Feedback
Domain (ANZAC) Station

Issue 1 - Location and function of various vents adjacent to 400 St Kilda Rd - Botanica

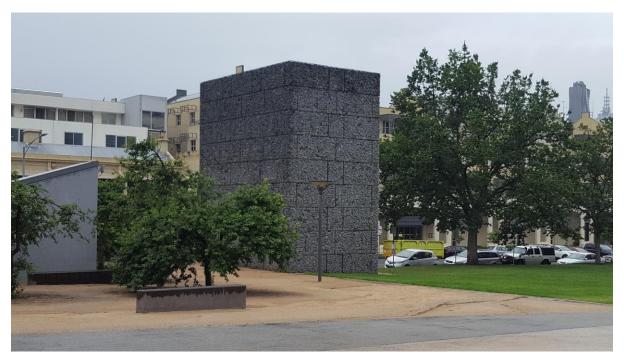
- Health risks
 - Increased likelihood for residents to contract asthma, legionella or other related respiratory illnesses
- Noise, vibration, odour
 - o Residents will be able to hear, feel or smell outputs from these vents.

- Visibly obtrusive
 - The Botanica is arguably the most impacted residential building in the entire Metro
 Tunnel project and one impact involves losing <u>all</u> eleven of the trees immediately
 outside our building. To then place these vents amongst the new planted
 replacement trees which will give little screening for many years

- We find it an incredible admission that the largest of the five vent structures could have been lower but has been made 5 metres high for architectural consistency.

- To suggest that a 5-metre-high, 10-metre-long "toilet block" could be acceptable by cladding it in bluestone is laughable.
- Zero consultation
 - o We meet regularly with MMRA and CYP this has NEVER been mentioned.

- We seek written assurance that our residents will not have increased likelihood of asthma, legionella or other related respiratory illnesses
- We seek written assurance that our residents will not be able to hear, feel or smell outputs from these vents
- We request the designers look at several suggested alternatives, including but not limited to
 - Lowering the height to 3 metres
 - Moving them closer to the eastern side of St Kilda Rd and further from residents. We are aware that a school exists on this side of the road but that side of the road is also maintaining fully mature trees and better able to screen the vents.
- We request that strong consideration is given to the roofing material used. The roof structure will be very visible to many of our residents in its current position.
